IREDELL COUNTY HEALTH DEPARTMENT
JANE MURRAY, RN BSN MS
HEALTH DIRECTOR

Re: Application for improvement permit for 2020 Charlotte Hwy Mooresville, NC 28115
Iredell County Health Department file number: 216054

Dollar General #216054

SOIL/SITE EVALUATION
***for* ON-SITE WASTEWATER SYSTEM**
(Complete all fields in full)

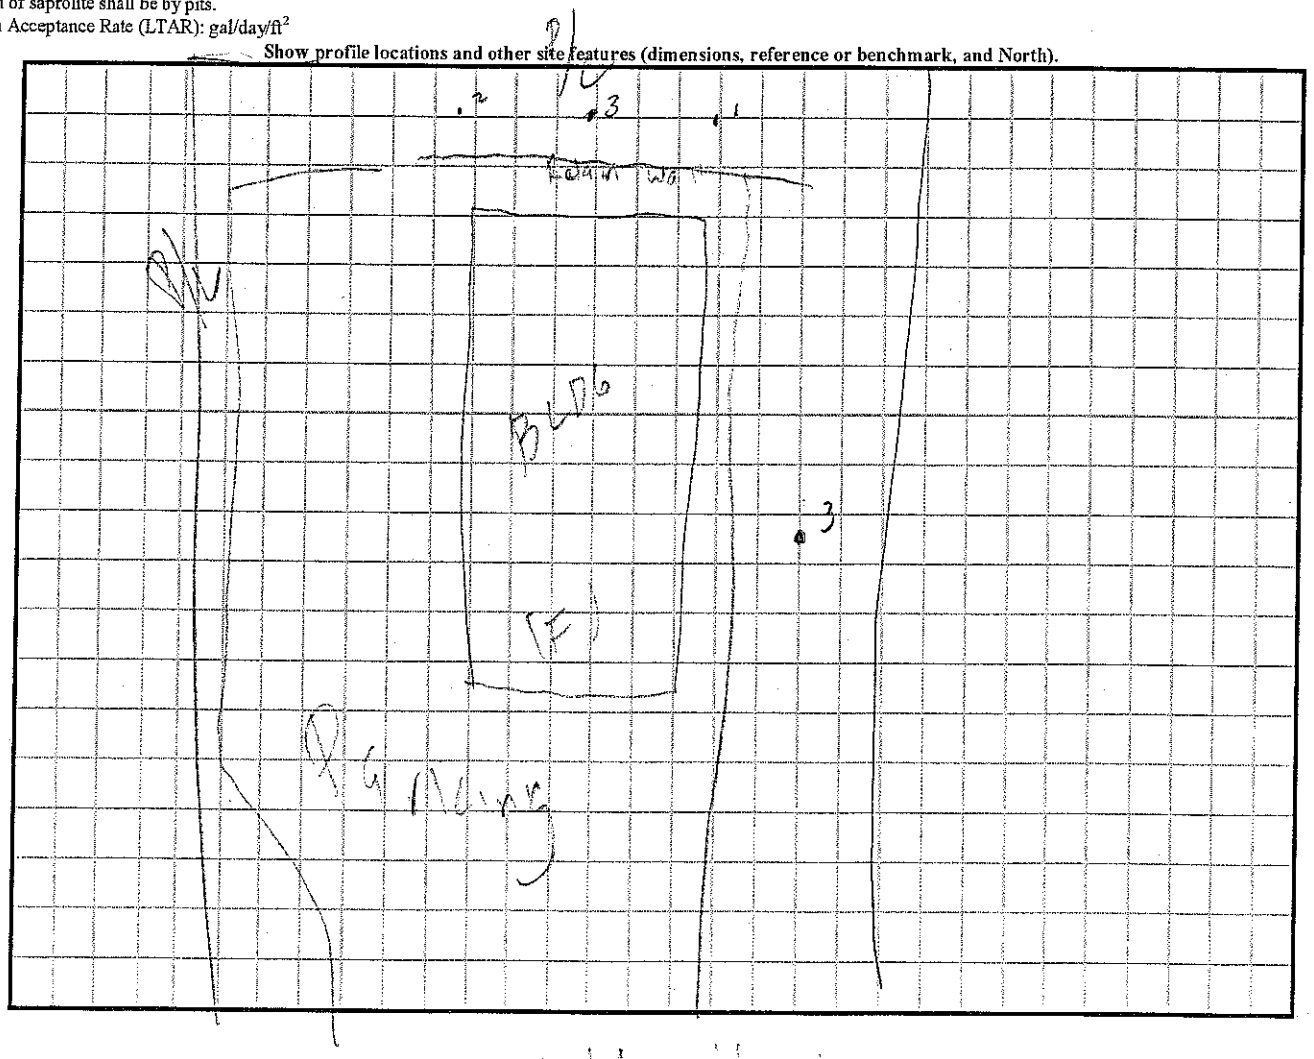
Based on the criteria set out in Title 15A, Subchapter 18A, of the North Carolina Administrative Code, Rule .1940 through .1948, the evaluation indicated that the site is UNSUITABLE for a sanitary system of sewage treatment and disposal. Therefore, we must deny your request for an improvement permit. A copy of the site evaluation is enclosed. The site is unsuitable based on the following:

_____ Unsuitable soil topography and/or landscape position (Rule .1940)
__X__ Unsuitable soil characteristics (structure or clay mineralogy) (Rule .1941)
__X__ Unsuitable soil wetness condition (Rule .1942)
_____ Unsuitable soil depth (Rule .1943)
_____ Presence of restrictive horizon (Rule .1944)
__X__ Insufficient space for septic system and repair area (Rule .1945)
_____ Unsuitable for meeting required setbacks (Rule .1950)
_____ Other (Rule .1946) _____

These severe soil or site limitations could cause premature system failure, leading to the discharge of untreated sewage on the ground surface, into surface waters, directly to ground water or inside your structure.

The site evaluation included consideration of possible site modifications, as well as use of modified, innovative, or alternative systems. However, the Health Department has determined that none of the above options will overcome

the severe conditions on this site. A possible option might be a system designed to dispose of sewage to another area of suitable soil or off-site to additional property.

For the reasons set out above, the property is currently classified UNSUITABLE, and no improvement permit shall be issued for this site in accordance with Rule .1948(c).

PROFILE #	.1940 LANDSCAPE POSITION/ SLOPE %	HORIZON DEPTH (IN.)	SOIL MORPHOLOGY (.1941)		OTHER PROFILE FACTORS				PROFILE CLASS & LTAR
			.1941 STRUCTURE/ TEXTURE	.1941 CONSISTENCE/ MINERALOGY	.1942 SOIL WETNESS/ COLOR	.1943 SOIL DEPTH	.1956 SAPRO CLASS	.1944 RESTR HORIZ	
1		0-12	Gr SCL	fr SE	Chroma 2's 12"-36" many yellow browns 36"-48"				UNS
		12-36	ABK C	fi SE/E					
		36-48	WABK BC	fi/fr SE/E					
2		0-10	Gr SCL	fr SE	Chroma 2's 10"-33" many yellow brown 33"-46" Black with manganese 33"-48"				UNS
		10-33	ABK C	fi SE/E					
		33-48	WABK BC	fi/fr SE/E					
3		0-14	Gr SCL	fr SE	Chroma 2's 12"-36" many yellow brown 36"-48"				UNS
		14-36	ABK C	fi SE/E					
		36-48	WABK BC	fi/fr SE					
4		0-20	Fill	—	Chroma 2's Gley				UNS
		20-48	WABK BC	fi SE/E

Note that a site classified as UNSUITABLE may be classified as PROVISIONALLY SUITABLE if written documentation is provided that meets the requirements of Rule .1948(d). A copy of this rule is enclosed. You may hire a consultant to assist you if you wish to try to develop a plan under which your site could be reclassified as PROVISIONALLY SUITABLE.
